Resource consent application – s92 request

Application number:	LUC60397719
Applicant:	Watercare Services Limited
Proposed activity:	The provision of minor infrastructure upgrades that are located within flood plains, overland flow paths, or areas of coastal inundation
Site address:	Various sites throughout Auckland associated with the consented central interceptor project

Note: sections are provided below that show areas where filling is proposed:

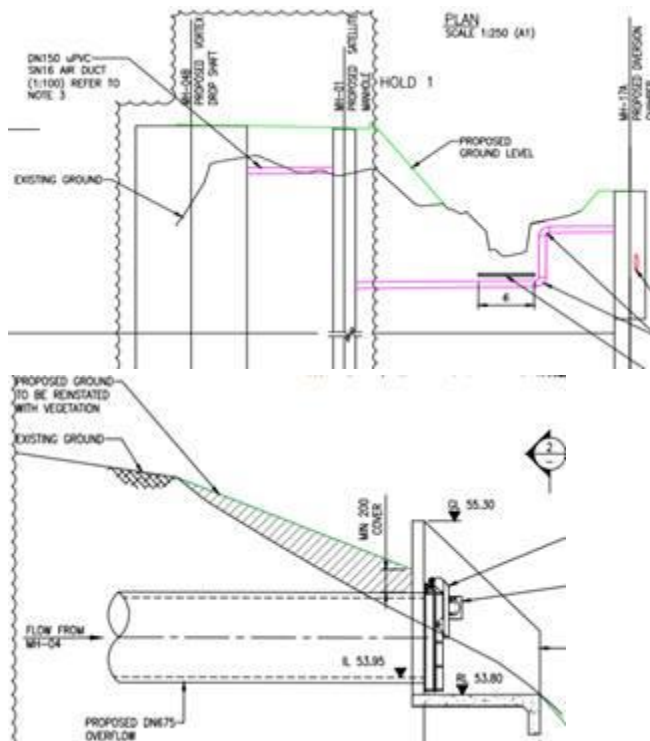
3. Please provide a flood / overland flow path risk assessment as per the special information requirements of Standard E36.9.(2) of the Auckland Unitary Plan (Operative in Part) (**AUP(OP)**). Please note that due to the nature of the proposed works, which involves filling in a flood plain, this cannot be deferred to consent condition stage and needs to be assessed as part of the resource consent assessment process.

4. Following on from question 3, please provide clarity on the total volume and depth of fill proposed within the flood plain.
5. Please provide evidence to support the statement that there 'be no exacerbation of existing flood risk' (Table 6.2 c within the assessment of environmental effects (**AEE**)), noting that the consent includes filling works within a flood plain which has not been addressed as part of the risk assessment and may result in a loss of available flood storage ,which would likely exacerbate flood risks offsite.
